## City of Ketchum

### **Recommendation to Hold a Public Hearing and Approve the Smiles Subdivision Lot Line Shift Final Plat & Findings of Fact, Conclusions of Law, and Decision.**

IN RE: )  
)  
Smiles Subdivision Lot Line Shift ) KETCHUM CITY COUNCIL  
Lot Line Shift ) FINDINGS OF FACT, CONCLUSIONS OF LAW, AND  
Date: November 18, 2021 ) DECISION  
)  
File Number: P21-084 )

**PROJECT:** Smiles Subdivision Lot Line Shift

Lot 1B, Block 1, Smiles Subdivision Plat

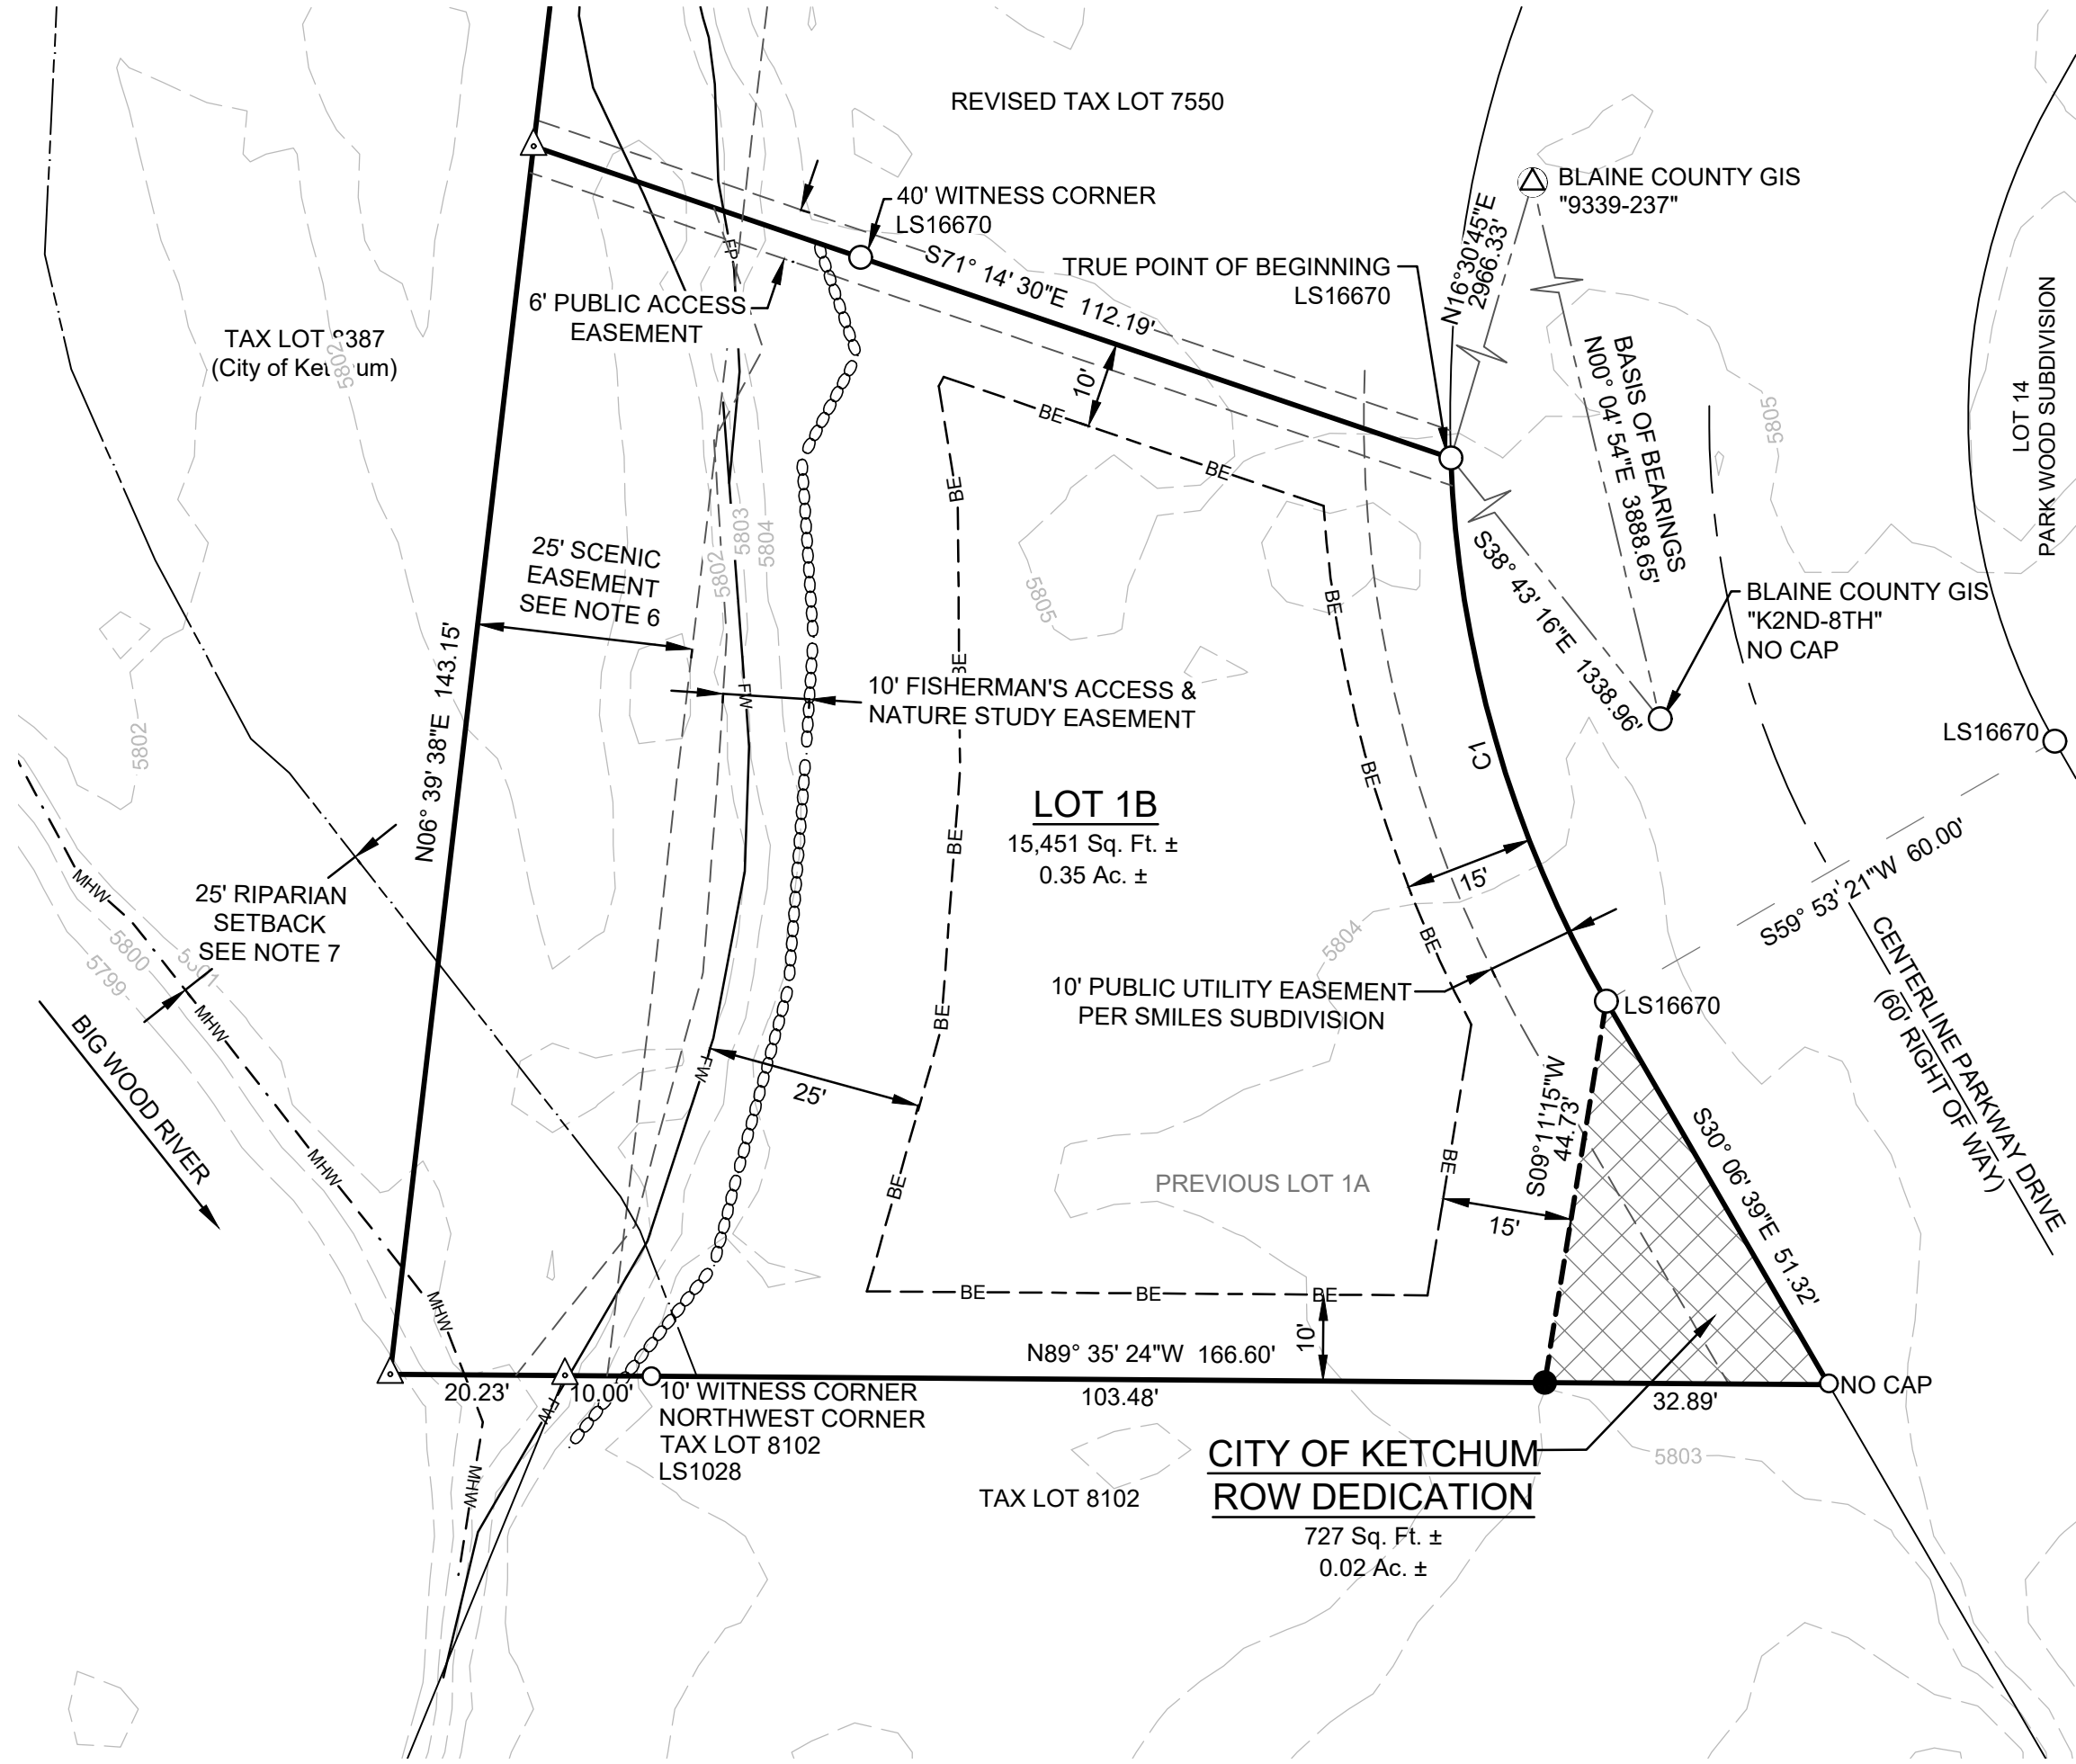
<b>Council Findings</b>	<p>The plat indicates Parkway Drive as well as the building envelope and public utility, public access, scenic, fisherman's access &amp; nature study easements. The boundaries of the floodplain and floodway are also shown on the plat.</p> <p>As conditioned, this standard shall be met. The final plat mylar shall show tract boundary lines, property lines, lot lines, street right of way lines and centerlines, other rights of way and easement lines, building envelopes as required on the preliminary plat, lot area of each lot, boundaries of floodplain and floodway and avalanche district, all with bearings, accurate dimensions in feet and decimals, in degrees and minutes and radii, arcs, central angles, tangents and chord lengths of all curves to the above accuracy.</p>
<input checked="" type="checkbox"/>	<input type="checkbox"/>	<input type="checkbox"/>	<b>16.04.030.K.4</b>	<b>Names and locations of all adjoining subdivisions.</b>

<b>Council Findings</b>	There are no adjoining subdivisions. The plat indicates the adjacent Tax Lots 7550 and 8102.
<input checked="" type="checkbox"/>	<input type="checkbox"/>	<input type="checkbox"/>	<b>16.04.030.K.5</b>	<b>Name and right of way width of each street and other public rights of way.</b>
			<b>Council Findings</b>	This standard has been met. The plat indicates the Parkway Drive public rights-of-way.
<input checked="" type="checkbox"/>	<input type="checkbox"/>	<input type="checkbox"/>	<b>16.04.030.K.6</b>	<b>Location, dimension and purpose of all easements, public or private.</b>
			<b>Council Findings</b>	This standard has been met. The plat indicates the public utility, public access, scenic, fisherman's access & nature study easements.
<input checked="" type="checkbox"/>	<input type="checkbox"/>	<input type="checkbox"/>	<b>16.04.030.K.7</b>	<b>The blocks numbered consecutively throughout each block.</b>

<b>Council Findings</b>	<i>Standard #1-6 have been met. Lot 1B complies with the dimensional standards required for lots within the LR Zone. As a portion of the lot is within the floodplain, a building envelope has been shown on the plat as per Standard #2.</i>
<input type="checkbox"/>	<input type="checkbox"/>	<input checked="" type="checkbox"/>	16.04.040.G	<p><b>G. Block Requirements:</b> The length, width and shape of blocks within a proposed subdivision shall conform to the following requirements:</p> <ol style="list-style-type: none"> <li>1. No block shall be longer than one thousand two hundred feet (1,200'), nor less than four hundred feet (400') between the street intersections, and shall have sufficient depth to provide for two (2) tiers of lots.</li> <li>2. Blocks shall be laid out in such a manner as to comply with the lot requirements.</li> <li>3. The layout of blocks shall take into consideration the natural topography of the land to promote access within the subdivision and minimize cuts and fills for roads and minimize adverse impact on environment, watercourses and topographical features.</li> <li>4. Except in the original Ketchum Townsite, corner lots shall contain a building envelope outside of a seventy five foot (75') radius from the intersection of the streets.</li> </ol>

<b>Council Findings</b>	<i>Standard #1 has been met. The plat indicates the required utility easement. Standards #2-4 have been met. The plat indicates the required 10' fish and nature study easement and 25' scenic easement. Standards #5-6 are not applicable.</i>
<input type="checkbox"/>	<input type="checkbox"/>	<input checked="" type="checkbox"/>	16.04.040.K	Sanitary Sewage Disposal Improvements: Central sanitary sewer systems shall be installed in all subdivisions and connected to the Ketchum sewage treatment system as a required improvement by the subdivider. Construction plans and specifications for central sanitary sewer extension shall be prepared by the subdivider and approved by the City Engineer, Council and Idaho Health Department prior to final plat approval. In the event that the sanitary sewage system of a subdivision cannot connect to the existing public sewage system, alternative provisions for sewage disposal in accordance with the requirements of the Idaho Department of Health and the Council may be constructed on a temporary basis until such time as connection to the public sewage system is possible. In considering such alternative provisions, the Council may require an increase in the minimum lot size and may impose any other reasonable requirements which it deems necessary to protect public health, safety and welfare.

1. The amended plat mylar shall meet all conditions specified in Table 1: Findings Regarding Contents of Final Plat and Subdivision Design & Development Requirements.

3. The recorded plat shall show a minimum of two Blaine County Survey Control Monuments with ties to the property and an inverse between the two monuments. The Survey Control Monuments shall be clearly identified on the face of the map.
